TB 132A

TECHNICAL BULLETIN

Product : Midilift XL+

Subject : Addition of cabin roof stop switch (revision A)

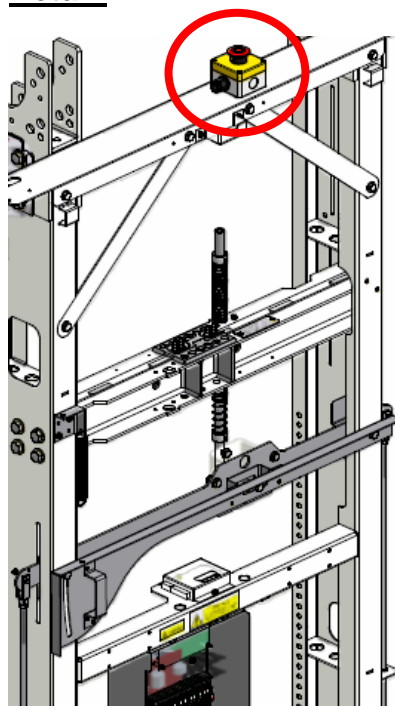
This is incorrect – activation of stop switch will prevent further movement of the lift with no fault code displayed. When released, the lift will return to normal service.

All Midilift XL+ lifts manufactured after 11/06/12 will have a cabin roof stop switch installed as standard.

The stop switch has been integrated into the safety chain and is located between ‘G7D’ and ‘G8’ terminals.
